Local Planning Panel

Address: 17 Billyard Avenue, Elizabeth Bay

Application Number: D/2021/1261

proposal

boarding room size

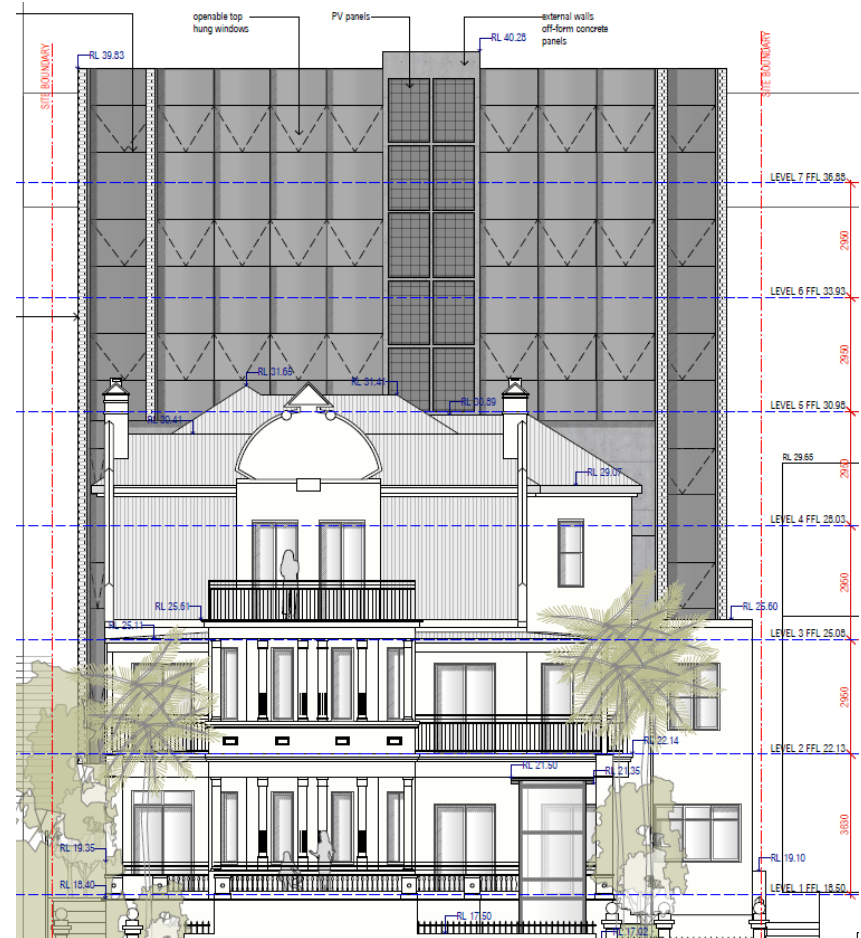
- kitchen area (11.3m²) shown is excessive, actual kitchen size is 2.5m²
- boarding room size exceeds 25m² maximum standard by 8.4m²
- no Clause 4.6 variation request

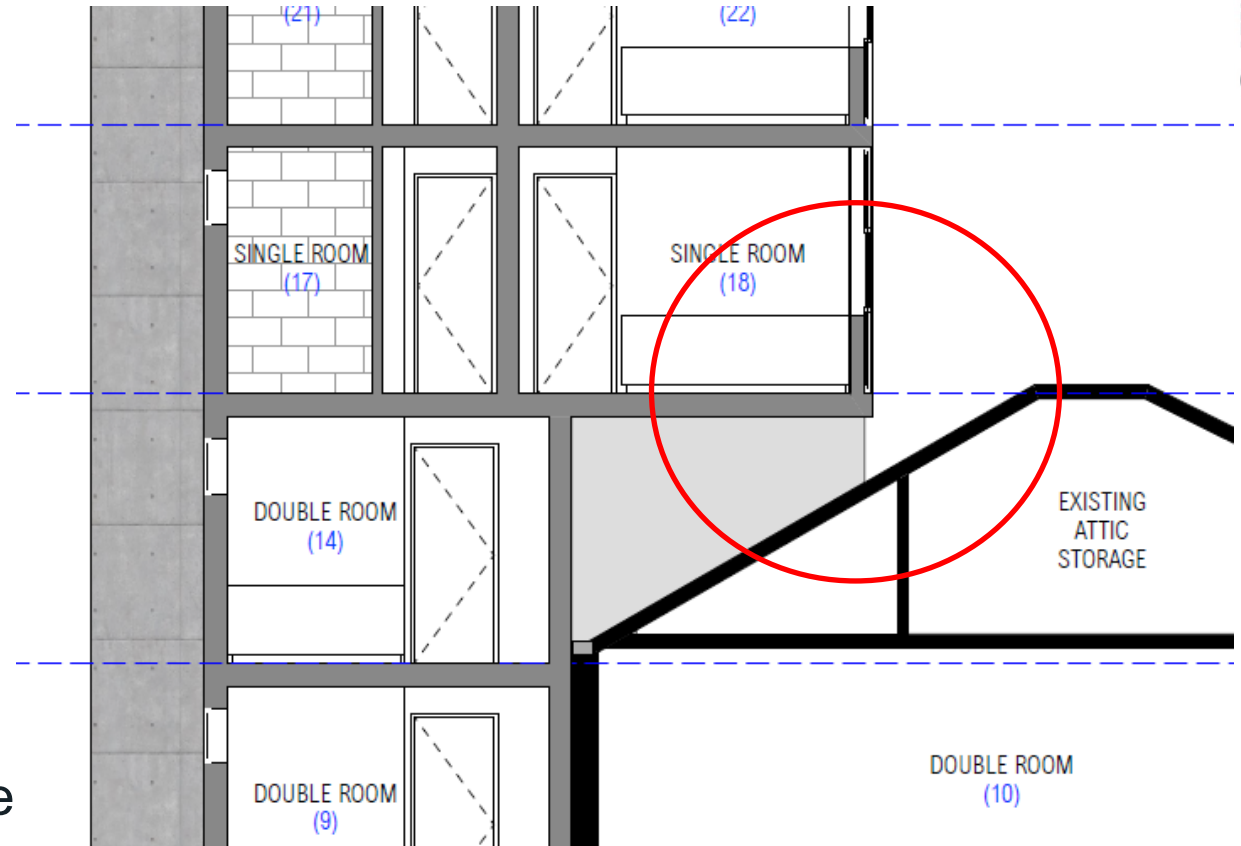
- bulk, scale and form of addition inappropriate to existing contributory building
- addition does not respect character and heritage significance of existing contributory building

june 21
10am

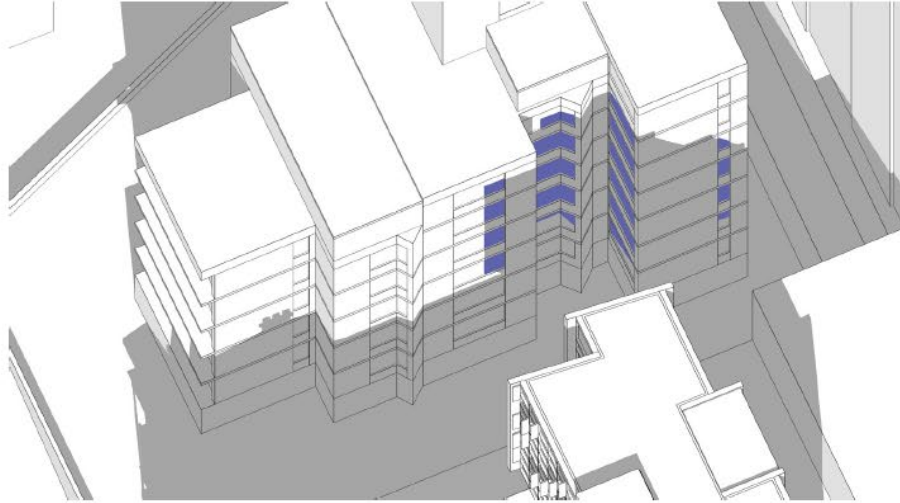
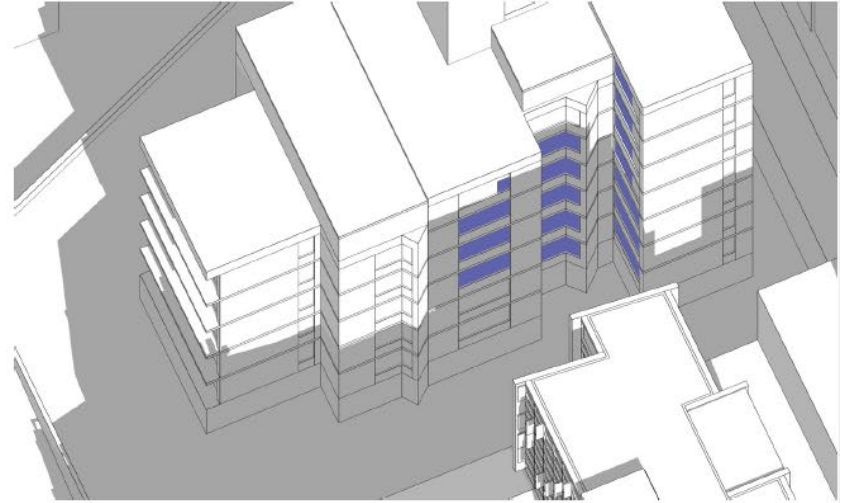
- sun's eye view diagrams not provided
- overshadowing impacts to RFB at 19-21 Billyard Ave

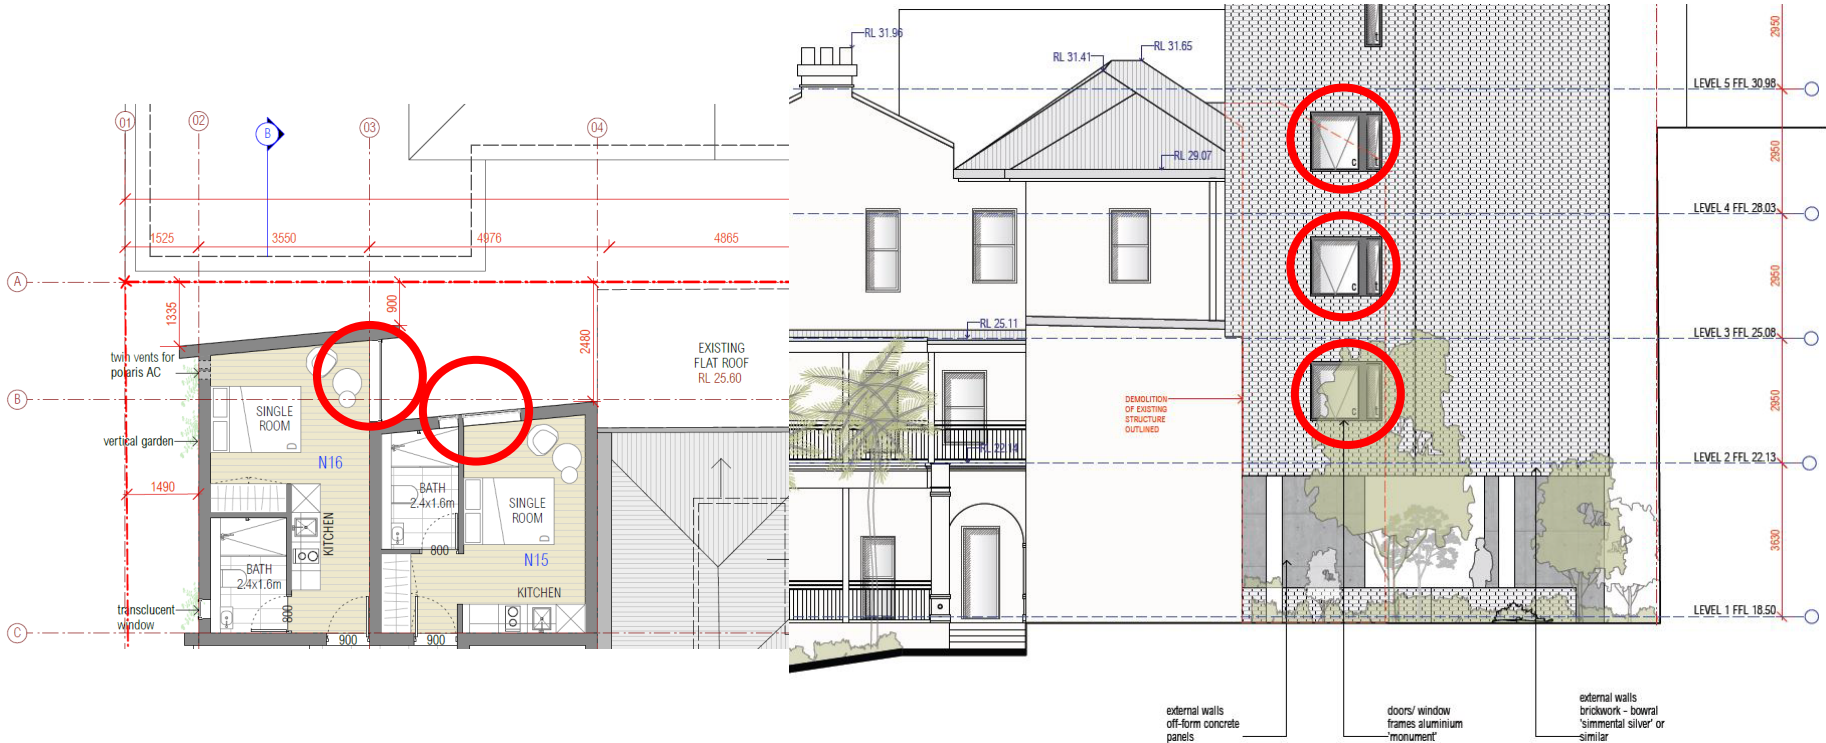
- potential privacy, overlooking and cross viewing impacts

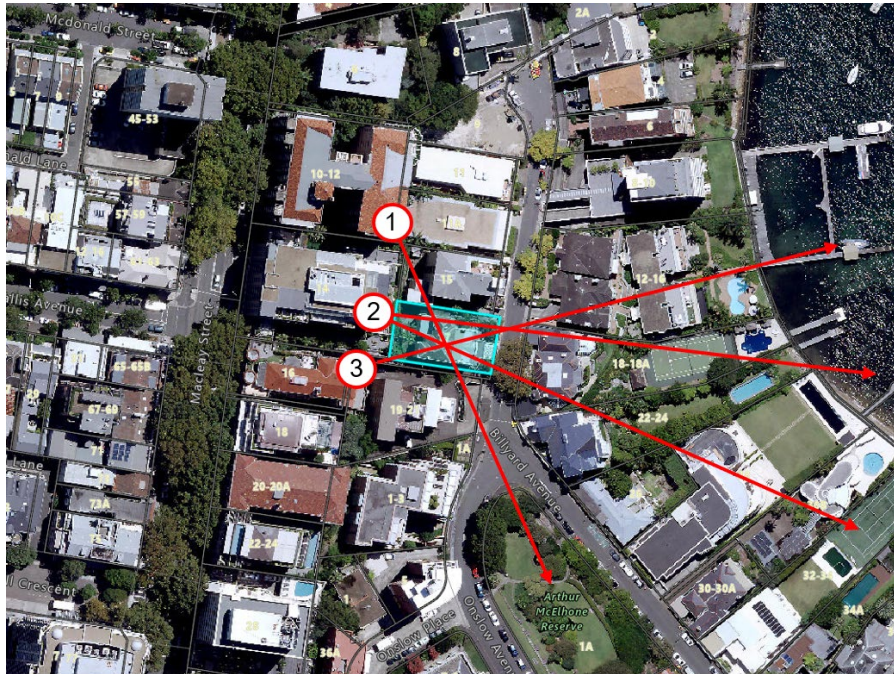
- view sharing assessment not provided
- appears to result in unacceptable view sharing impacts

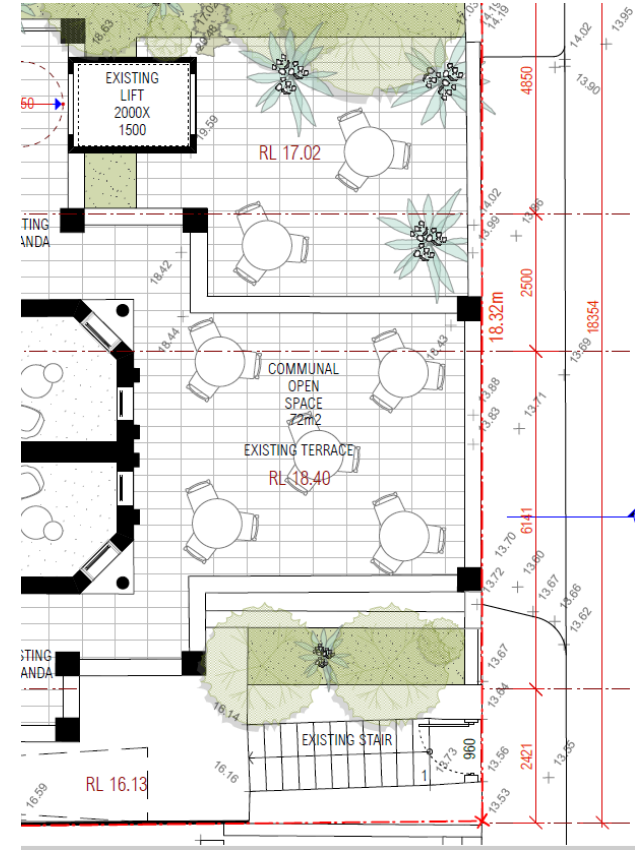
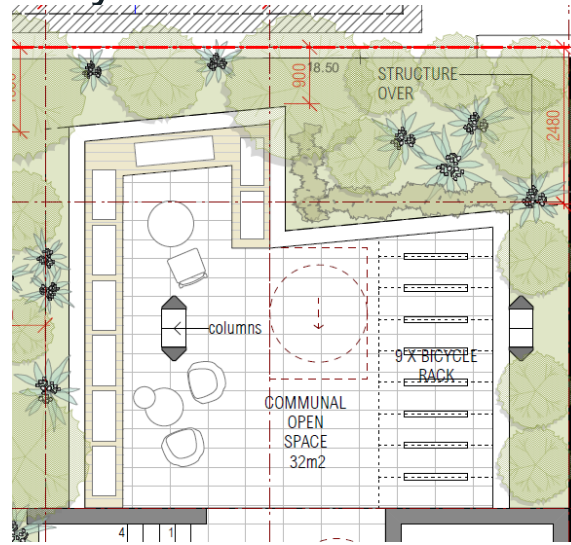
- poor amenity to western communal open space (within undercroft)
- elevated level 1 eastern communal open spaces to Billyard Ave may result in amenity impacts

june 21
9am

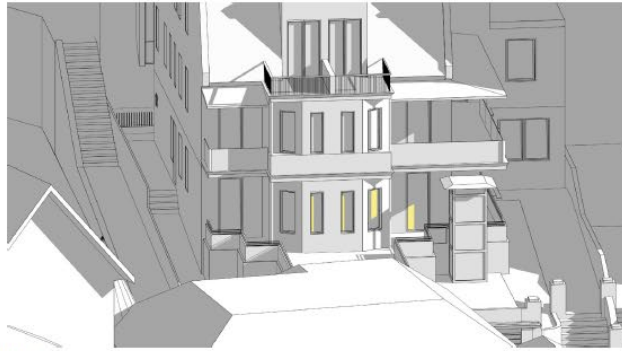
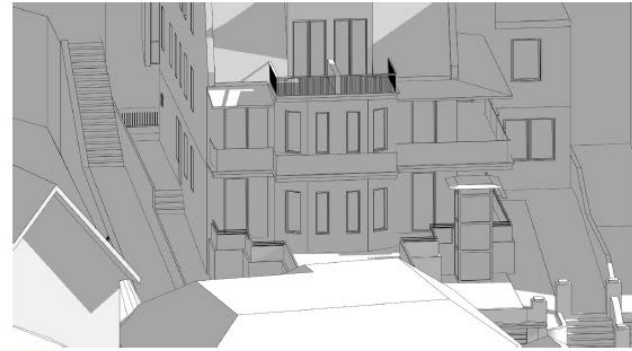
- level 1 communal living rooms do not receive compliant solar access

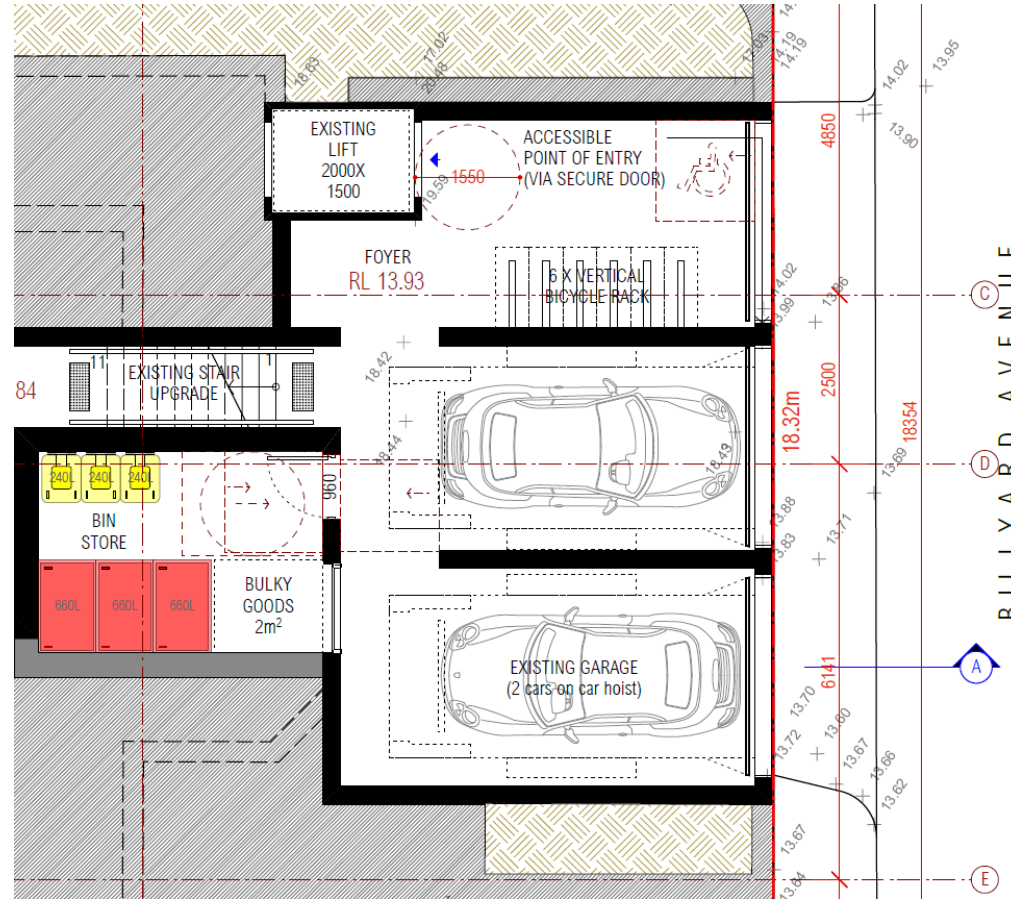
- no accessible parking provision
- no service vehicle parking provision
- insufficiently detailed waste management plan
